# Technical Service Bulletin

## 72 Audi Q5 rattle from left rear seat back

72 12 04 2030729/2 November 30, 2012. Supersedes Technical Service Bulletin Group 72 number 12-03 dated September 5, 2012 for reasons listed below.

*Figure 3. 2/3 seatback frame.*

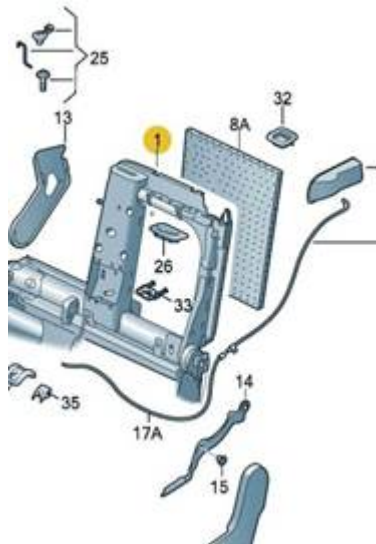
If a rattle noise is heard, start diagnosis by way of a test drive with a partner. Have your partner drive while you sit in the right rear of the vehicle leaving no objects or passengers in the left rear side of the seat. This rattle is best diagnosed under these conditions. If the source of the rattle is the 2/3 rear seatback, the 2/3 rear seat backrest frame torsion bar is not serviceable. The 2/3 rear seatback frame must be replaced.
